CAPRICORN MUNICIPAL DEVELOPMENT GUIDELINES

2026 MEETING 3 MINUTES

Venue: Teams
Date and Time: 14th May 2026 at 11am

SLUCE VALVE (Ø300 OR LESS - SOFT CLAY)

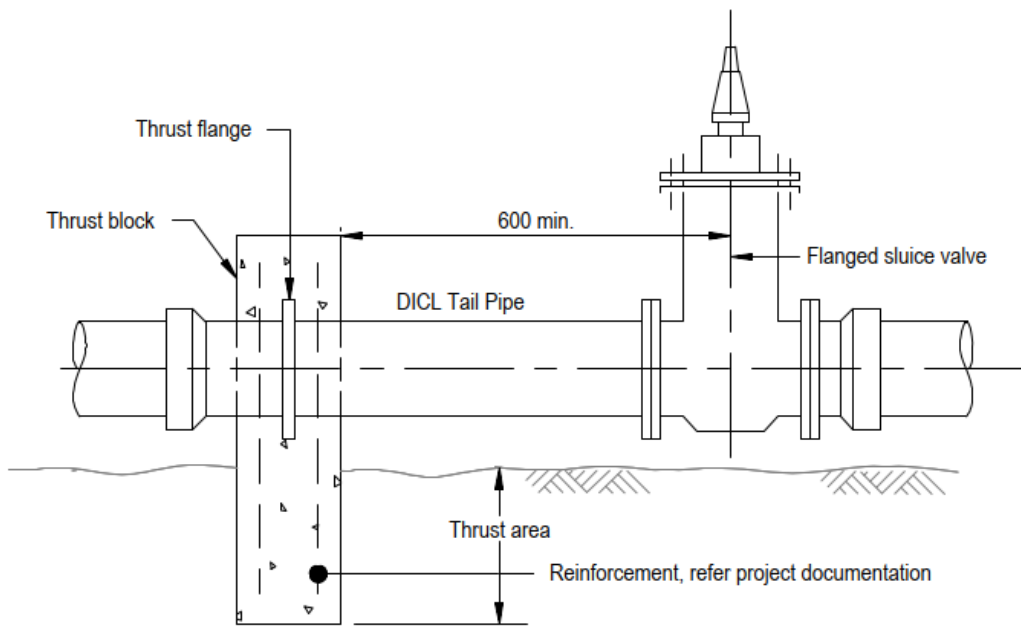
M25.07.02	<p>Watermain Thrust Blocks</p> <p>Lack of details around restraint of watermains at fittings/valves has been noted – a recent project provided details to restrain socket/spigot main connections at transitions to flanged or other end</p>

terminations, the example detail is show below for reference.

It has been noted that without providing restraint, when the valve is closed there are no equalising force to stop the socket/spigot main connections from separating. This could lead to failures during maintenance.

Further discussion is requested to determine if this has been an issue historically, and to gauge committee interest in updating thrust block details and specifications to ensure thrust restraint is provided at valve locations for future construction.

Additional to the above, it has been raised that the thrust block minimum thrust area table in W-041 doesn't specify concrete volume or thickness.

Richard advised that the details regarding restraint were likely lost over previous revisions of CMDG drawings. Queried if the committee would be agreeable to add detail similar to WBBROC standard on restraint, as well as providing more clear information on thrusting volumes and areas etc.

Update CMDG standard drawings in line with SEQ and WBBROC drawings.

Committee confirmed agreement to make the suggested changes.

<p><u>M2026.03 Resolution</u></p> <ul style="list-style-type: none"> - MCE to make the suggested changes to the necessary documentation. <p>Action By MCE</p>				
M25.07.03	<p>Maximum Sewer Depth</p> <p>The origin of the existing section D12.20.16 <i>Maximum Inlet Depth</i> has been queried. This has highlighted the inconsistency of this section with actual practice, noting that inlets are often deeper.</p> <p>It is suggested this section be removed so as to not provide hard limitations to what is often a project specific design requirement.</p> <p>Further, the limitation on gravity sewer depth of 3.5m maximum is suggested to be relaxed to a desirable maximum, or in accordance with the manufacturers specification.</p> <table border="1" data-bbox="309 577 1449 808"> <tr> <td data-bbox="309 577 1241 689">D12.20.16. The maximum depth of the inlet pipe invert is 3.5m.</td> <td data-bbox="1241 577 1449 689"><i>Maximum Inlet Depth</i></td> </tr> <tr> <td data-bbox="309 689 1241 808">D12.10.04. The <u>desirable maximum</u> depth of a reticulation sewer main is to be a maximum of 3.5m to invert of pipe. <u>Deeper sewer mains may be acceptable where provided in accordance with the pipe manufacturers specifications.-</u></td> <td data-bbox="1241 689 1449 808"><i>Maximum Sewer Main Depth</i></td> </tr> </table> <p><u>M2026.03 Discussion</u> Richard raised that the provided 3.5m was limiting and difficult to achieve in practice typically.</p> <p>Grant suggested agreement but would confirm with FRW prior to adoption of the change.</p> <p><u>M2026.03 Suggested resolution</u></p> <ul style="list-style-type: none"> - RRC to confirm with FRW - Other LGA's to confirm internally and advise. <p>Action by MCE</p>	D12.20.16. The maximum depth of the inlet pipe invert is 3.5m.	<i>Maximum Inlet Depth</i>	D12.10.04. The <u>desirable maximum</u> depth of a reticulation sewer main is to be a maximum of 3.5m to invert of pipe. <u>Deeper sewer mains may be acceptable where provided in accordance with the pipe manufacturers specifications.-</u>	<i>Maximum Sewer Main Depth</i>
D12.20.16. The maximum depth of the inlet pipe invert is 3.5m.	<i>Maximum Inlet Depth</i>				
D12.10.04. The <u>desirable maximum</u> depth of a reticulation sewer main is to be a maximum of 3.5m to invert of pipe. <u>Deeper sewer mains may be acceptable where provided in accordance with the pipe manufacturers specifications.-</u>	<i>Maximum Sewer Main Depth</i>				
M26.01.01	<p>Water Meter Street Preference</p> <p>There have been a few recent cases where the location of the water meter relative to the street for multi-frontage lots has been raised. I.e. if a lot is known as 6 CMDG Street, but it also has a rear or side frontage to 10 Side Street, and both streets have a water main available for connection, can the water meter be located on any of these streets. Currently, there is nothing in D11 that specifies this.</p> <p><u>M2026.03 Discussion</u></p> <p>Mohit advised RRC's preference is to provide meters at the most logical point assuming all other aspects (hydrants) comply.</p> <p><u>M2026.03 Suggested Resolution</u></p> <ul style="list-style-type: none"> - No addition to D11 required. - Close item. 				
M26.01.02	<p>Watermain standard alignment</p> <p>LSC have encountered an issue with watermains clashing with sewer chambers on the standard 2.5m (water) and 1.8m (sewer) alignments.</p> <p>LSC have suggested a 2.7m standard alignment.</p> <p>It shouldn't be an issue for LSC, in terms of impacts to other services etc, to change the standard alignment for LSC. However, most other LGAs don't have the additional 1m of verge width and the watermain has potential to interact with the tree pits.</p>
